City of West Linn
PRE-APPLICATION CONFERENCE MEETING
Notes
September 2, 2010

SUBJECT: Installation of roof above patio, and supporting pillars, at 18406 Old River Landing, in Flood Management Area

City of West Linn GIS (Geographic Information System), SnapMap Date: 8/25/2010

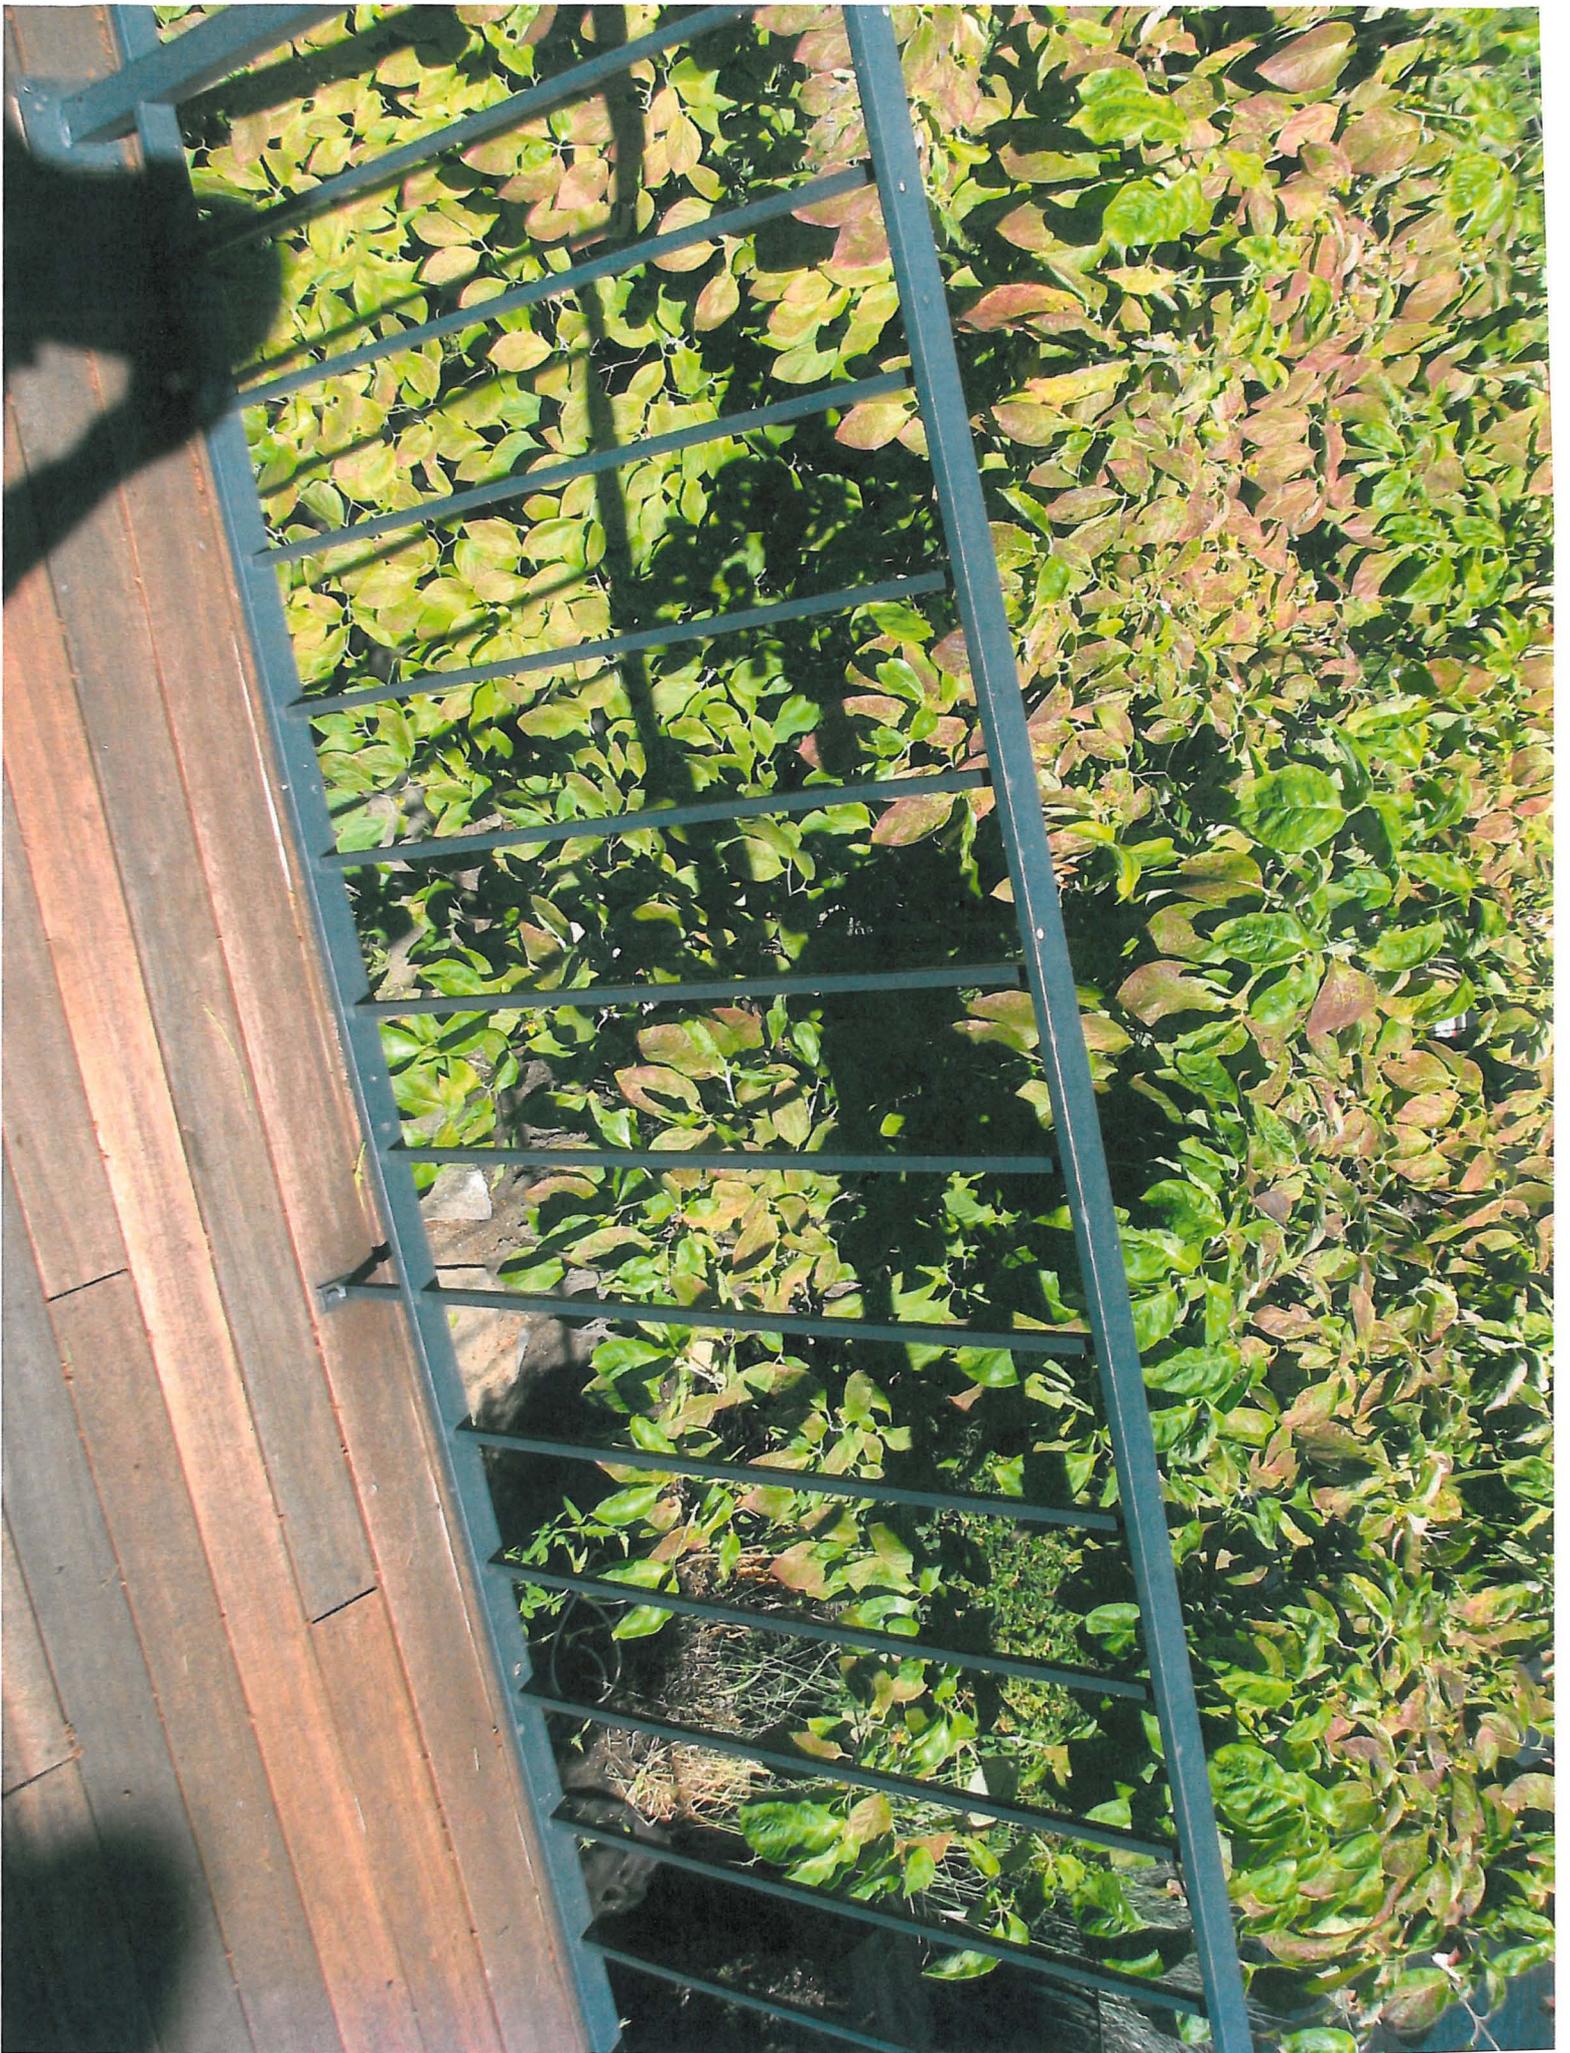
Per City GIS the most of the patio except for the area underneath the cantilevered second floor is in the 1996 flood area (and except for a 1-2 foot section northeast of this along most of the patio). Also, the north corner of this area of the patio is in the floodway (unusually, the floodway gives way to a 500-year floodplain here, with no 100-year floodway in between). If the roof has pillars that touch to the ground in the 1996 flood area and/or floodway, the Flood Management Area (FMA) permit is needed. Per Community Development Code (CDC) 27.020, "A flood management area permit is required for all development in the Flood Management Area Overlay Zone." All areas in the floodway and in the 1996 flood area are part of the Flood Management Area Overlay Zone. The City's interpretation of 27.020 however is that this does not apply to second floor or higher areas, as these are not where flooding is expected. Therefore the FMA permit is not needed if the proposed patio roof is cantilevered out at second floor level with no pillars.

On the same side of the house the applicant proposes to construct a basement room where there currently is none below the existing room on the first floor adjacent to the patio (the room southwest of the patio). Per City GIS the basement addition is not in the floodway, 100-year floodplain, or 1996 flood area, so the Flood Management Area permit technically does not have to address this part of the development proposal. The 1996 flood plain overlaps with the cantilevered roof area by a foot or two at the most on the

GIS aerial view, and the first floor room and proposed basement room start approximately 8 feet southwest of the edge of the cantilevered second floor, so they do not appear to be in the flood management area.
